# 1981 Corvette: Service Bulletin: Glow Around Wiper Switch Rework Wiper Switch Bezel

**Subject:** GLOW AROUND WIPER SWITCH REWORK WIPER SWITCH BEZEL

**Model and Year:** 1981 Corvette

**Bulletin Number:** 81-I-19

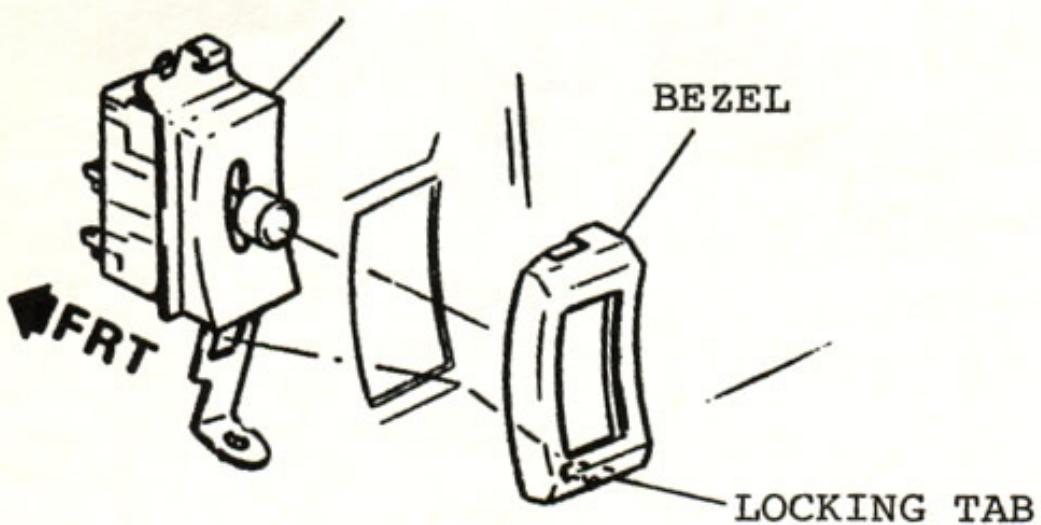
SOME EARLY 1981 CORVETTES WITH SILVER, RED, OR RUST TRIM MAY EXHIBIT A GLOW AT NIGHT AROUND THE WIPER SWITCH BEZEL. IN THESE COLORS, THE BEZEL BASE MATERIAL IS "NATURAL" AND COULD BECOME TRANSLUCENT WITH LIGHTS TURNED ON. THE REMAINING BEZEL COLORS WERE PAINTED OVER A BLACK BASE MATERIAL AND ARE NOT AFFECTED.

THE GLOWING CONDITION CAN BE ELIMINATED BY REPLACING THE ORIGINAL BEZEL WITH P/N 14016216, WHICH IS BLACK AND MUST BE PAINTED TO MATCH TRIM COLOR. THE BEZEL HAS A LOCKING TAB WHICH ENGAGES THE WIPER SWITCH AS ILLUSTRATED ON PAGE 2.

## CORVETTE WIPER SWITCH BEZEL ATTACHMENT

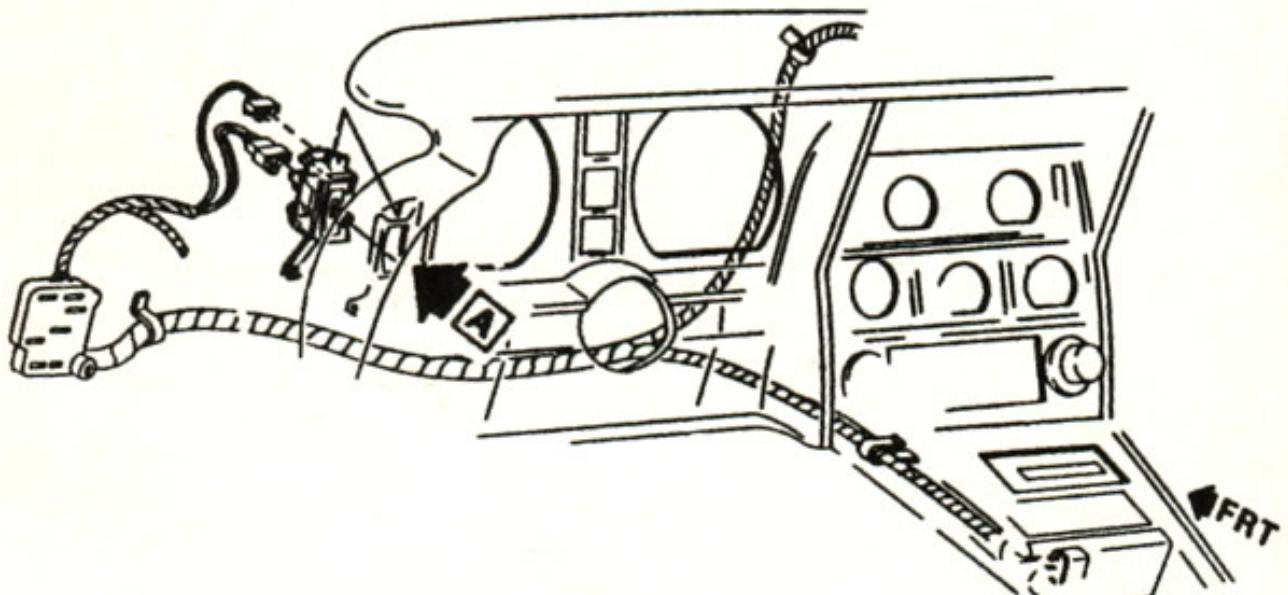
REPLACEMENT REQUIRES SETTING THE STEERING COLUMN TO ITS LOWEST TILT POSITION, REMOVING THE SPEEDOMETER CLUSTER, AND REACHING THROUGH THE INSTRUMENT PANEL TO DISCONNECT THE BEZEL LOCKING TAB.
